Technical Service Bulletin

**MODEL(S)
AFFECTED:****Tennant R14**

SUBJECT:

**Potential Hose Failure Location****Solution Hose Kit 9003386 Contents**

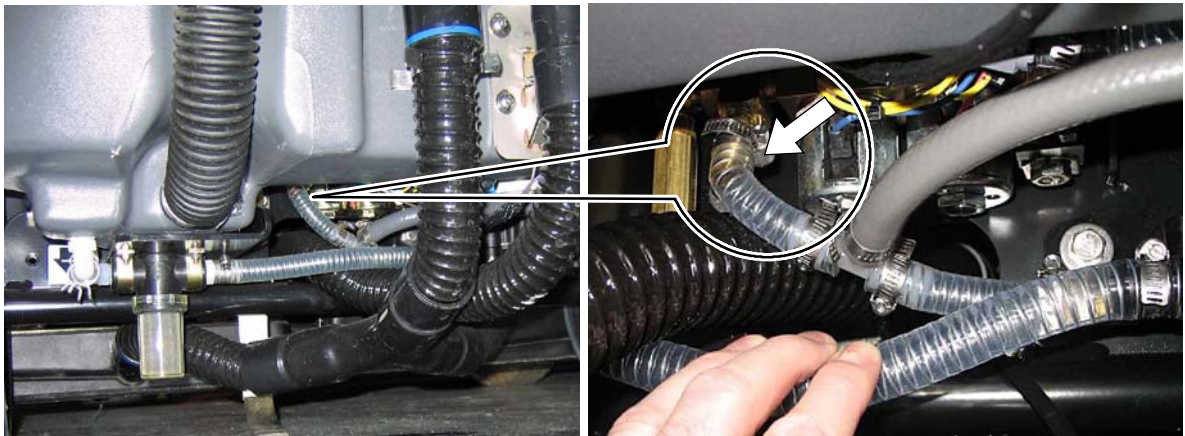
Solution Hose failure - Reports have been received that the solution hose routed to the solution tank fitting is splitting or bursting (see location below).

To repair or to prevent potential hose failure, install Solution Hose Kit p/n 9003386. The kit is designed to reduce the stress at the fitting connection, plus the hoses are rated for higher pressure.
